## MEMORANDUM

**Subject:** Dave Ullin Open Water Marina – Buoy Installation

**PROJECT:**  
**BAINBRIDGE ISLAND DAVE ULLIN OPEN WATER MARINA**

**TITLE:**  
**BUOY LAYOUT WITH AS-BUILT LOCATIONS**

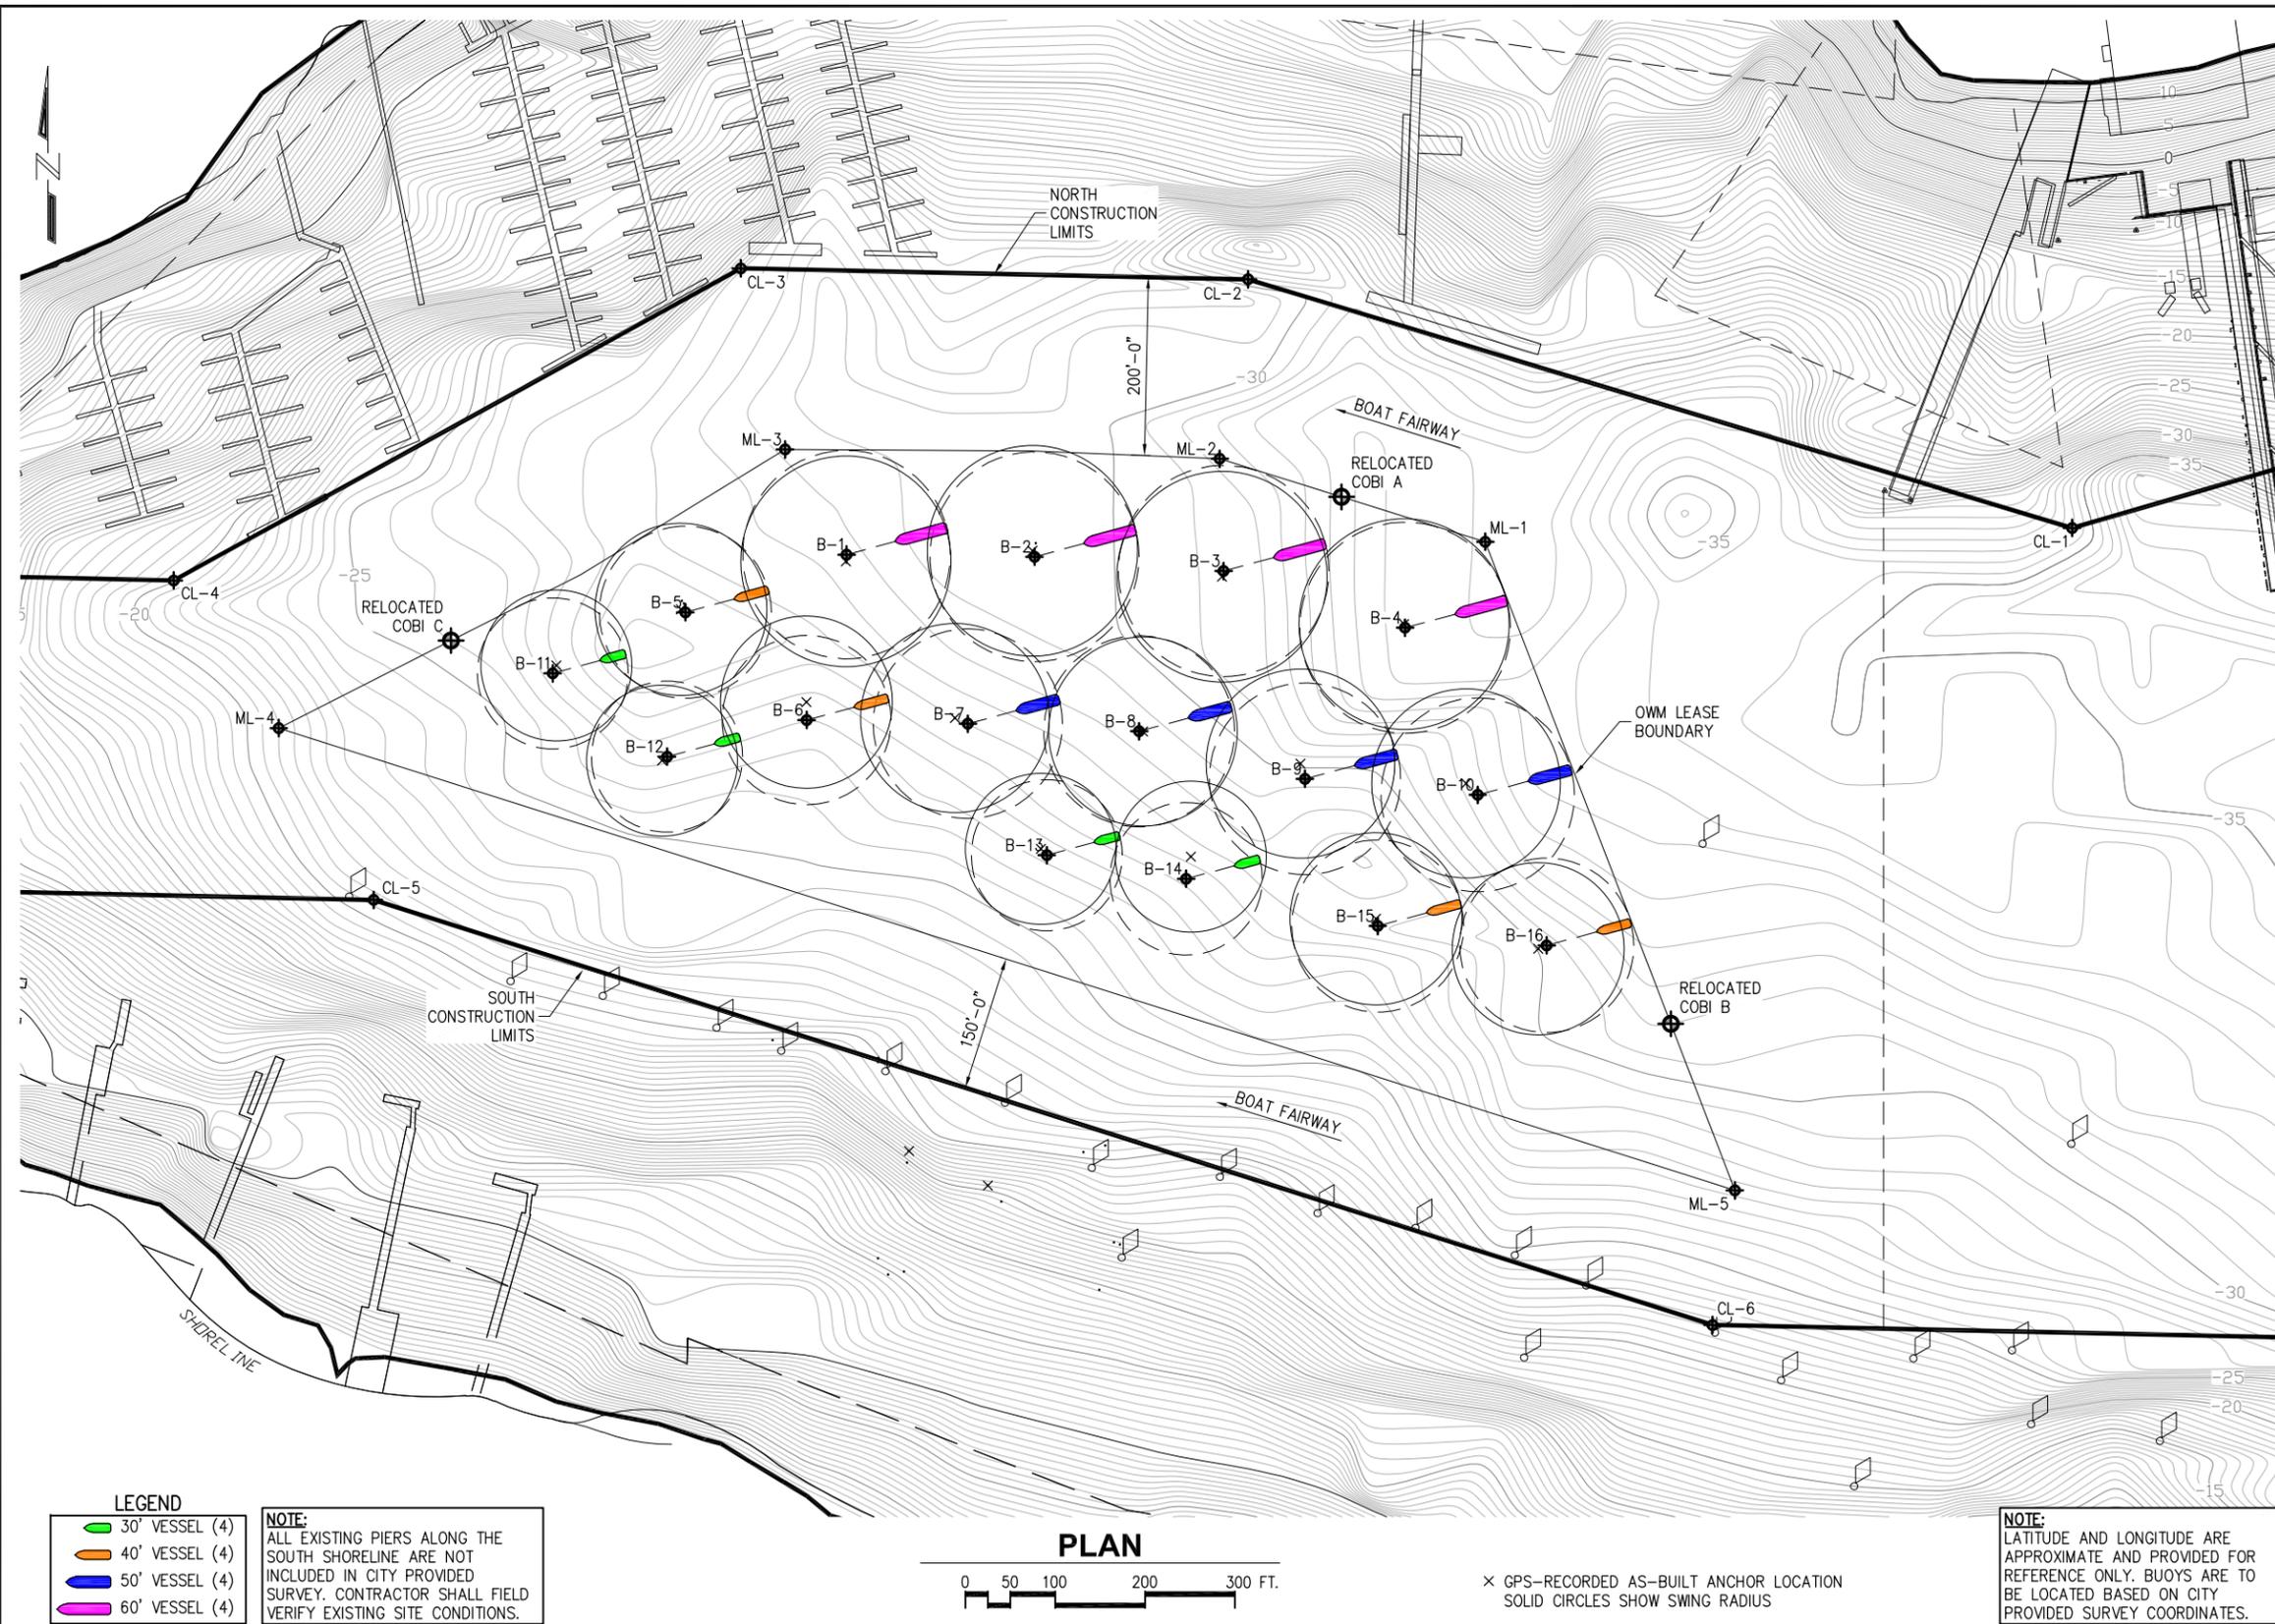
PND has also recorded as-built locations of the buoys by handheld Garmin GPS. Considering typical error margins for such GPS units, PND can confirm that the buoys, and vessels moored to them as specified in the design drawings, will not interfere with each other in design wind and current conditions. An as-built site plan is attached showing the recorded buoy locations and swing circles.
